S16 PLANNING APPLICATION
APPROVED TONG YAN SAN TSUEN OZP NO. S/YL-TYST/14

**Section 16 Planning Application for Proposed Minor Relaxation of
Building Height and Plot Ratio Restrictions
for Permitted Public Housing Development at
Long Bin, Yuen Long
(Application no. A/YL-TYST/1285)**

Reference is made to the captioned Section 16 application received by the Town Planning Board on 27.9.2024 and the comments received from Planning Department dated 15.10.2024, 24.10.2024, 30.10.2024, 31.10.2024, 4.11.2024, 6.11.2024 and 13.11.2024. We submit herewith the table summarizing HD's responses to the comments as well as the replacement pages and illustrative drawings to substantiate the application.

DRAWING TITLE
INDICATIVE LANDSCAPE MASTER PLAN (All levels)

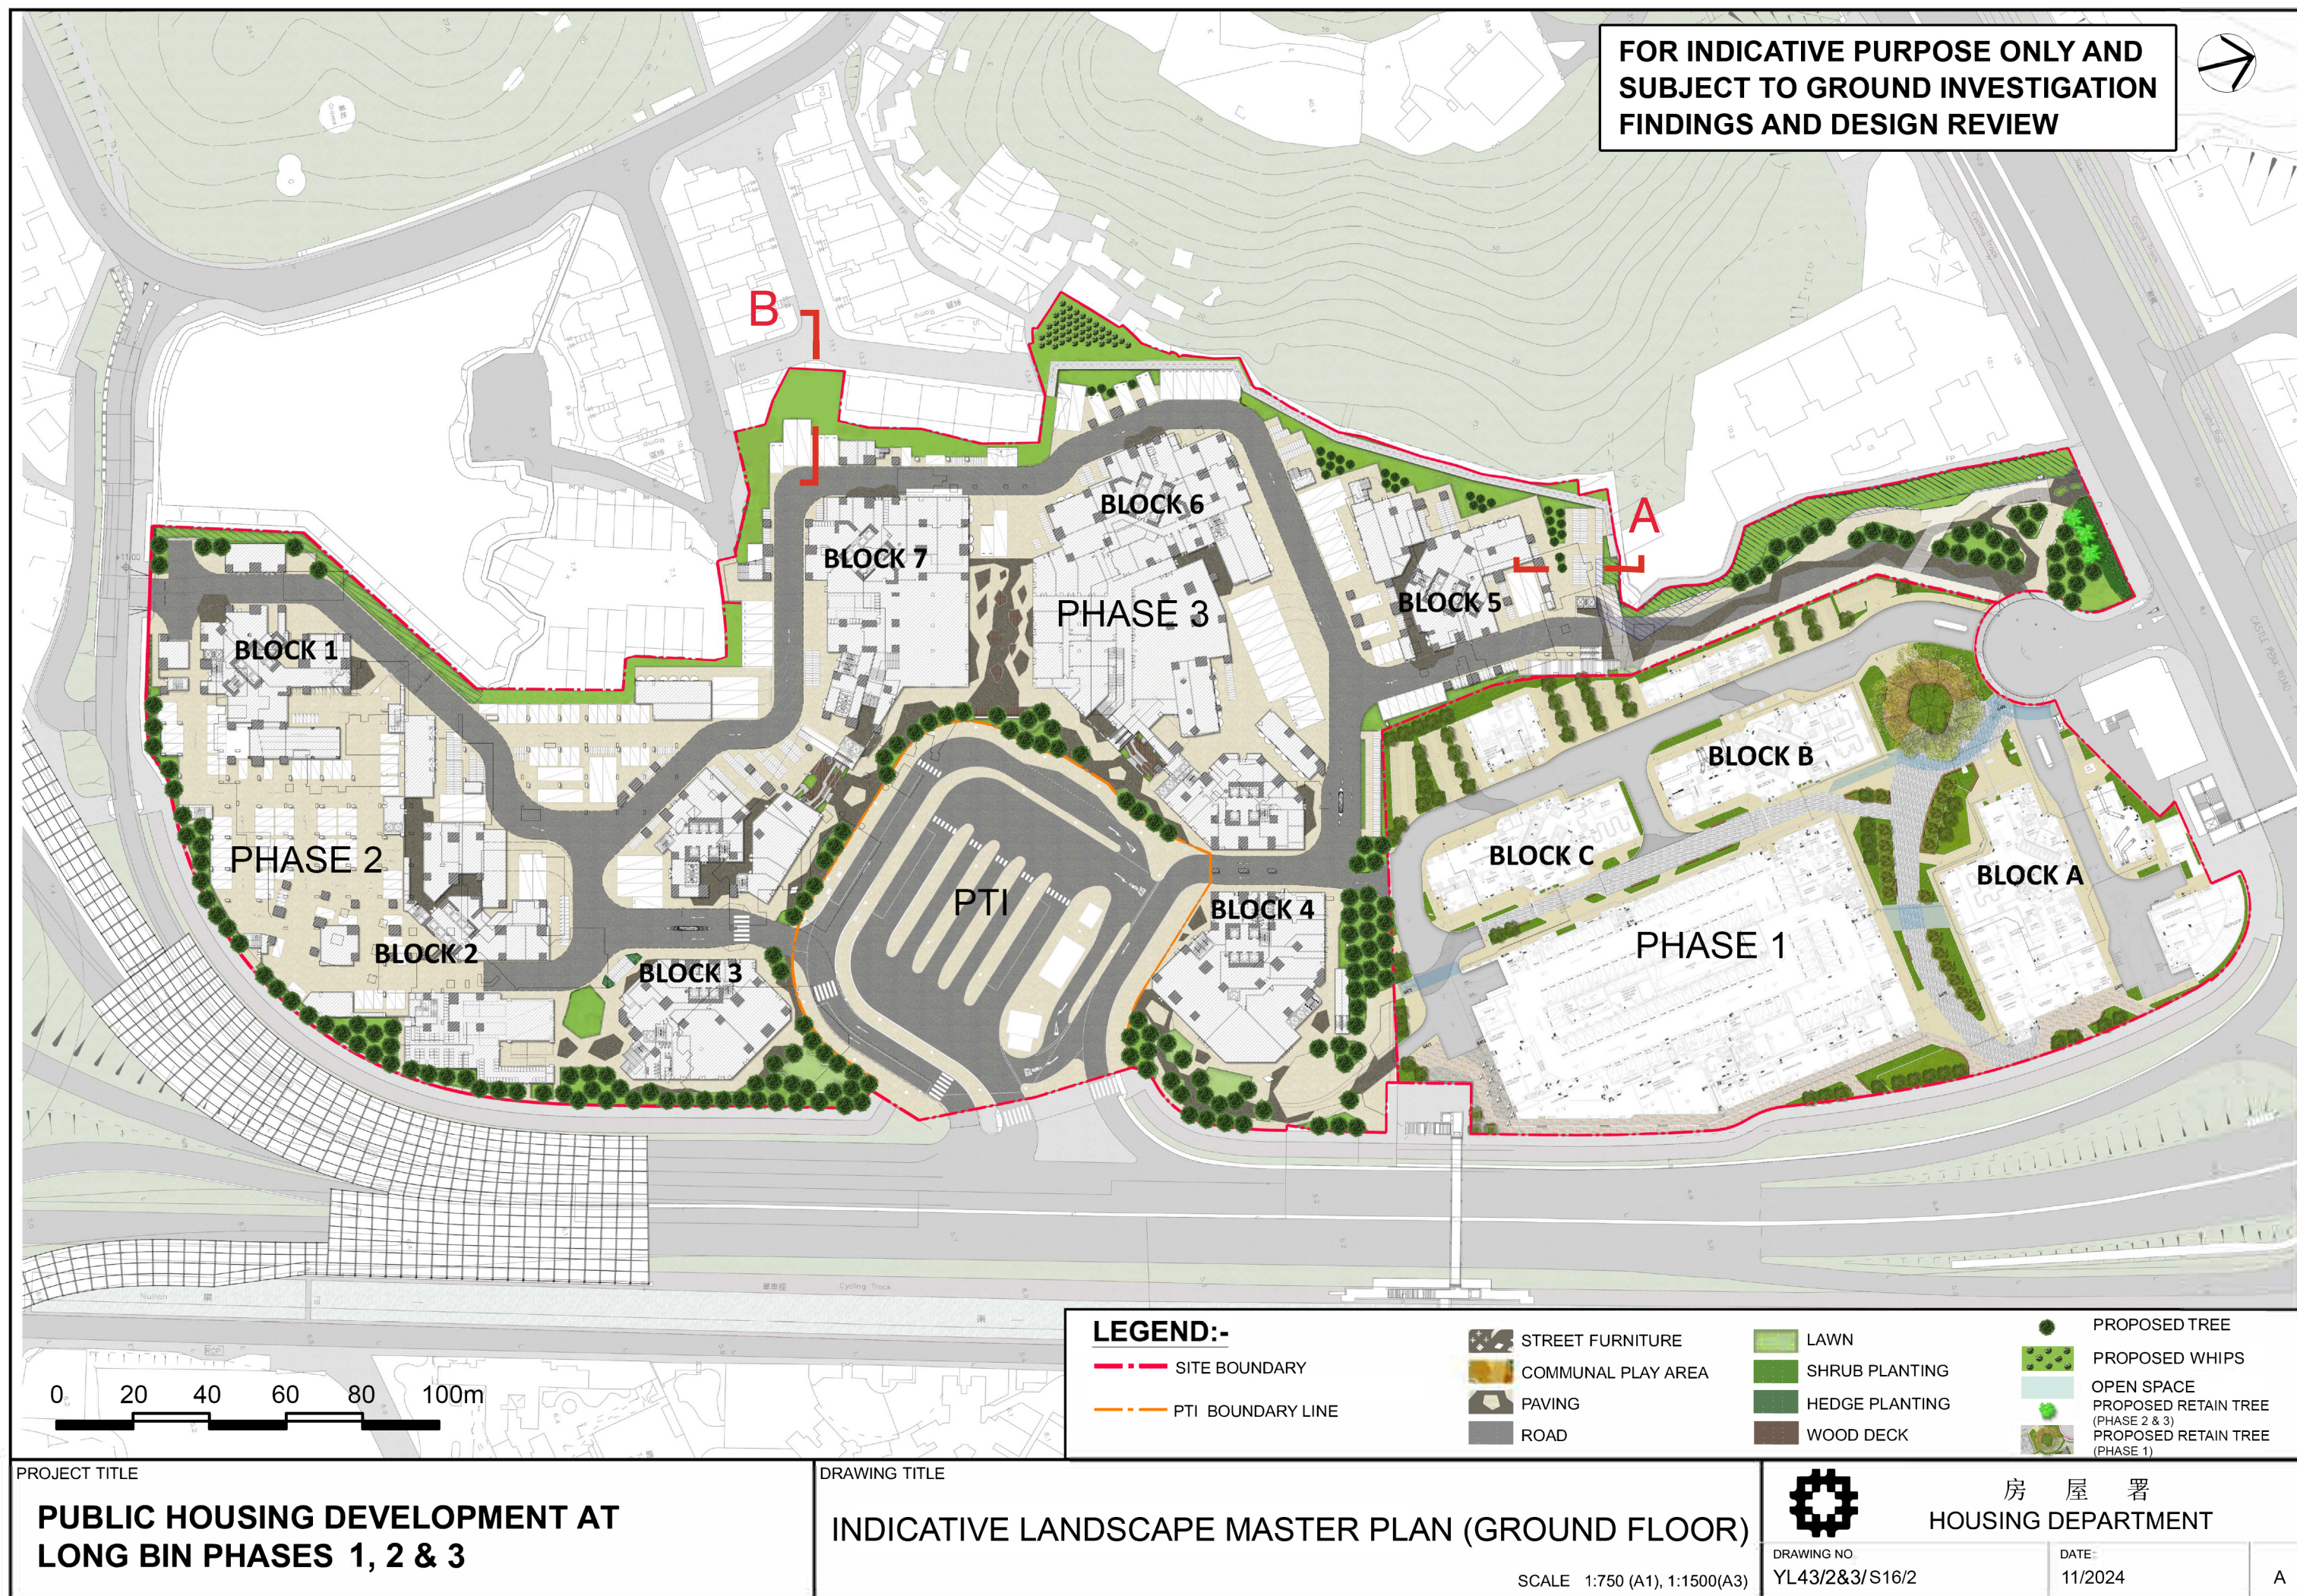
<p>7. Having reviewed the submitted information, please provide the below required information for our consideration.</p> <p>(a) Based on the Indicative Landscape Master Plan of the application site (including Phases 1, 2 and 3), the Applicant should provide the Sections and Elevations to demonstrate the proposed landscape design and boundary treatments on the eastern</p>	<p>As requested, two additional indicative sections of western boundary have been supplemented in Attachment 4. Section A is on the boundary abutting Villa Sunshine near Block 5 and Section B is on the boundary abutting Green Lodge near Block 7.</p>

(c) Please provide scale bar on the Indicative Landscape Master Plans.	Noted. Please refer to the revised Indicative Landscape Master Plans (Figures 5 to 8) in Attachment 4 .

Comments	Responses
	<p>aforementioned application, a total 466 new trees proposed to plant within the development site were recorded. Even though the Applicant (i.e. HKHA) under current planning application (No. A/YL-TYST/1285) mentioned in para. 4.7 of the Supporting Planning Statement that <i>“Tree compensation will be undertaken by CEDD based on the approved TPRP and no compensatory tree will be provided within the Application Site”</i>, however, when comparing the Indicative Landscape Master Plans under the above mentioned planning applications (No. A/YL-TYST/1074 and A/YL-TYST/1285), the overall tree planting areas seems to be significantly reduced in the current Indicative Landscape Master Plan which may cause remarkably diminishing effect (466 new trees vs. 284 new trees, i.e. about 40% reduction) on the overall landscape quality and setting. We opine that the number of new tree planting as committed by previous planning application for the Site should be followed unless with sound justification. The Applicant should consider to increase the greening and tree planting opportunities on the Phases 2 and 3 development especially the eastern portion of the Site and proposed planting areas where opportunity for more new trees planting are observed.</p>	<p>previous approved planning application (No. A/YL-TYST/1074) were prepared and submitted by another Applicant (i.e. CEDD). Our submission is prepared based on the latest scheme design and other technical considerations.</p> <p>Upon reviewed the latest Indicative Landscape Master Plans, approximately a total of 320 new trees and 46 whip trees are now proposed in Phases 2 and 3. In this regard, a total 466 new trees proposed to plant (including approximately 100 new trees in Phase 1) within the Site can be complied. Nevertheless, as the project is still under very preliminary stage, the number of trees proposed is subject to detailed design, site constraints during construction stage and the prevailing government / statutory guidelines / requirement on greening provision and tree planting.</p> <p>Para. 4.8 of the Supporting Planning Statement and the Indicative Landscape Master Plans (Figures 5 to 8) have been revised accordingly (Attachment 4).</p>

Comments	Responses
	boundary of the proposed development which are in close proximity to the existing residential blocks.	
	(b) The Applicant should consider to increase the greening opportunity on the Phases 2 and 3 development such as the eastern portion of the Site adjacent to the existing residential blocks and proposed planting areas with sparse tree planting.	Please be advised that there are drainage reserve area required by the Drainage Services Department in Section A and existing compacted soil in Section B which impose constraints in tree provision in the western portion of the Site. Nevertheless, in order to maximize greening provision of the Phases 2 and 3 development as far as practicable, hydroseeding is proposed on the slope. Also, new tree planting provision is increased over the Site, of which a total 466 new trees are proposed to plant (including approximately 100 new trees in Phase 1) within the Site.

Figure 1

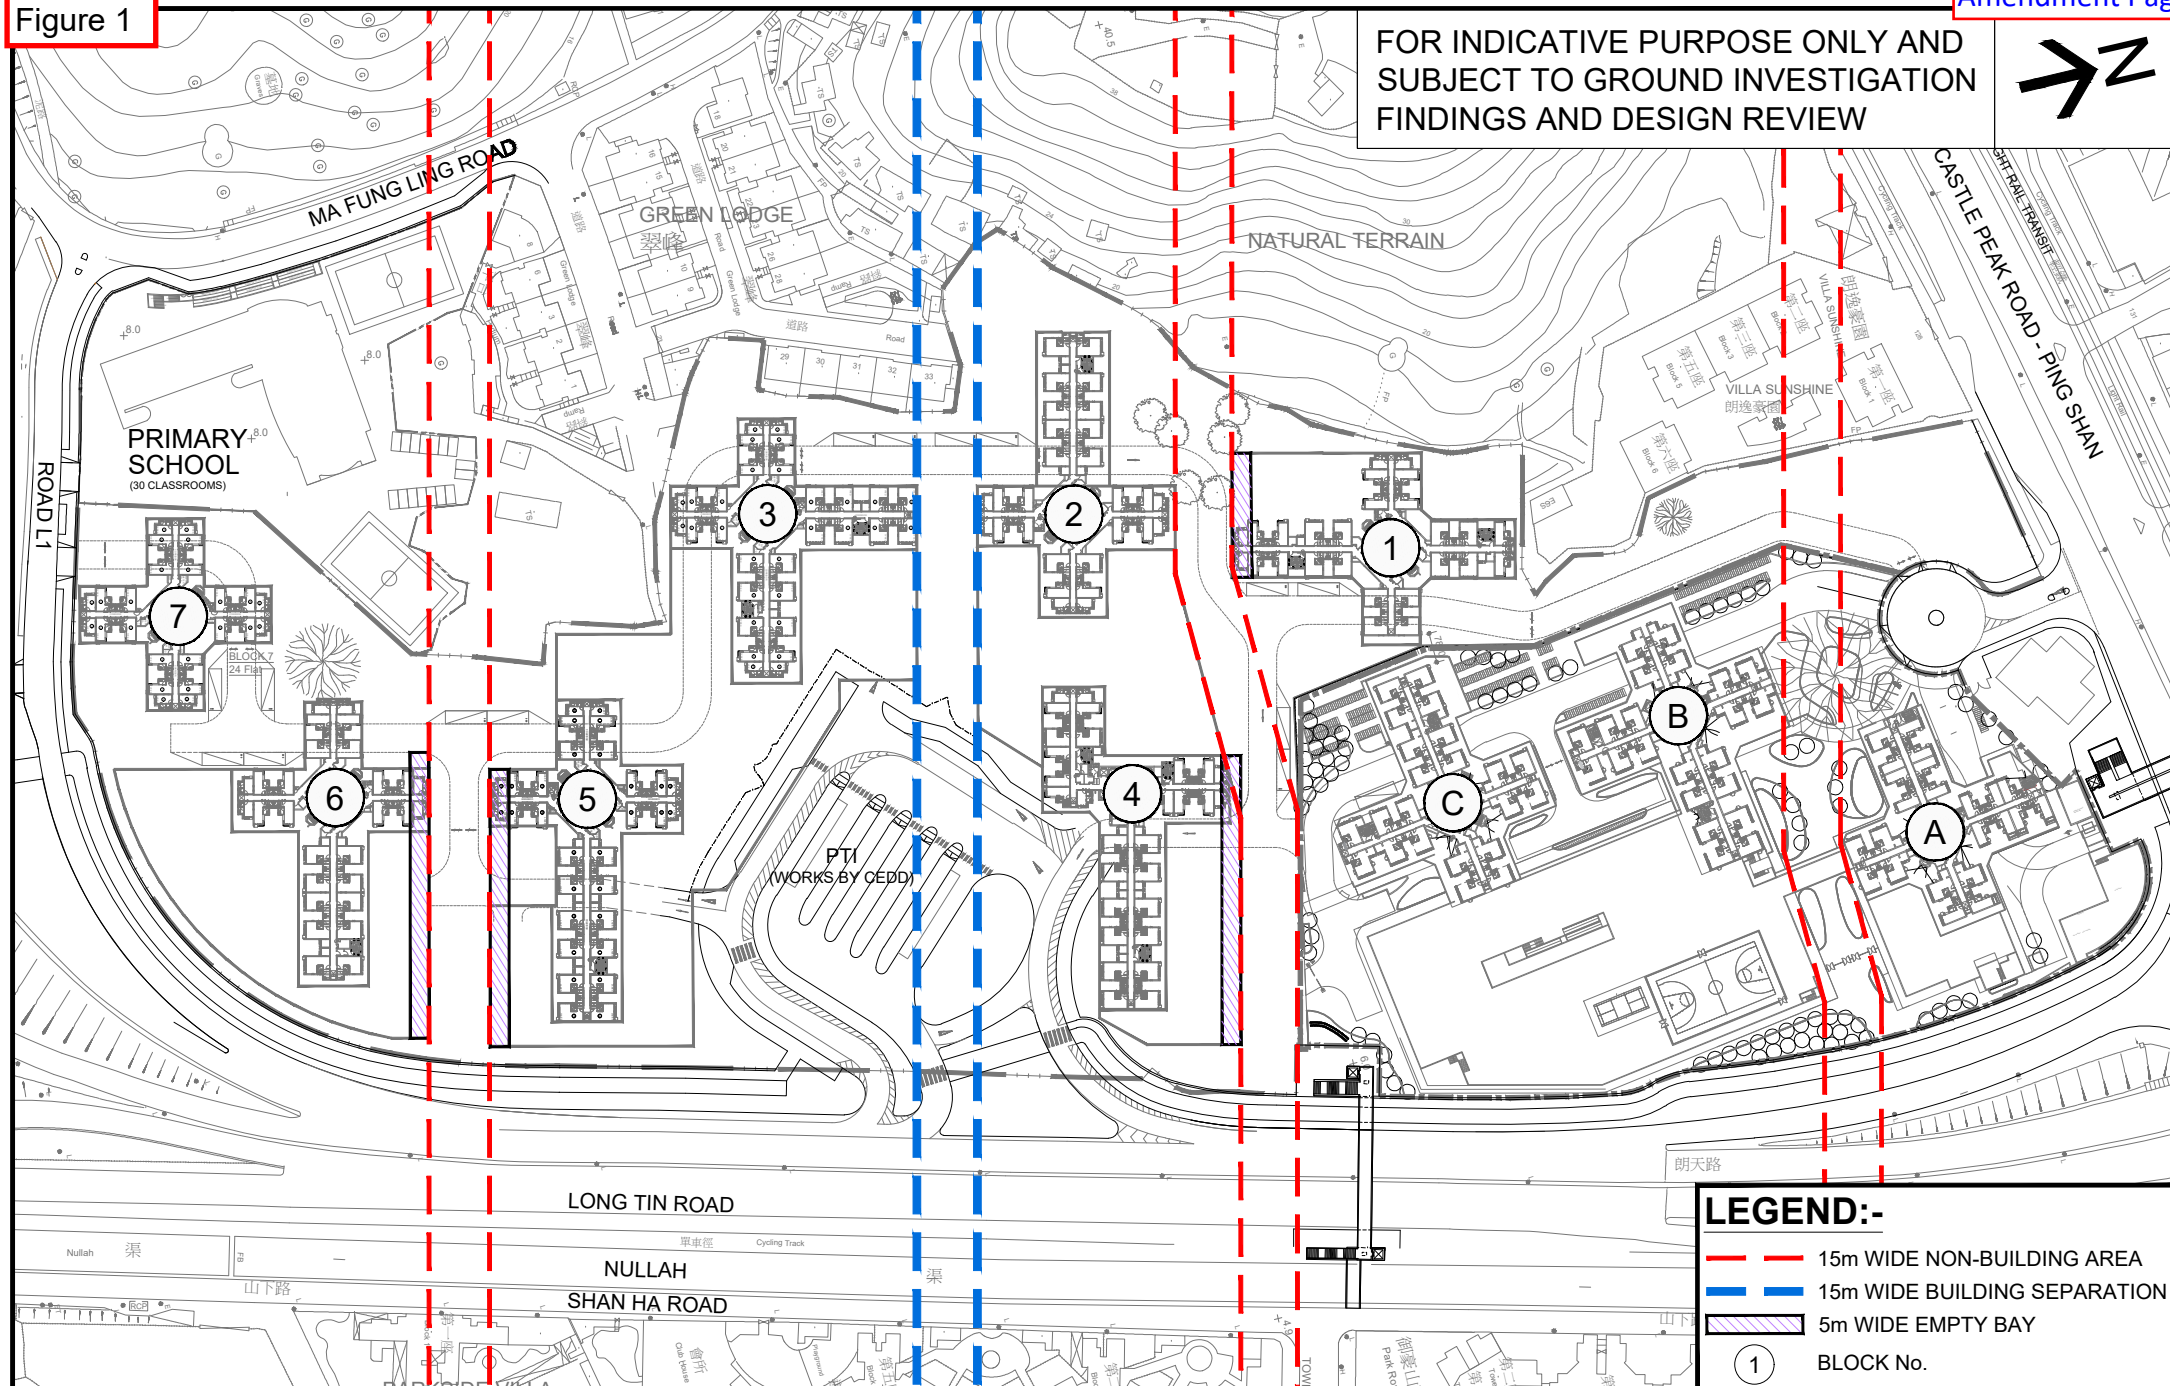
Comments	Responses
	/ Retail / Educational and Other Supporting Facilities”.	
	<p><u>Figure 1 of the Qualitative Statement on Air Ventilation Assessment and Plans 2 to 10 of the Qualitative Statement On Visual Impact Assessment</u></p> <p>- Please replace the phrase “Current Scheme” to “Approved s.16 Application No. A/YL-TYST/1074 (Current Scheme)” for clarity.</p>	<p>Noted. Please refer to the revised Figure 1 of the Qualitative Statement on Air Ventilation Assessment in Attachment 5 and the revised Plans 2 to 10 of the Qualitative Statement On Visual Impact Assessment in Attachment 7 respectively.</p>
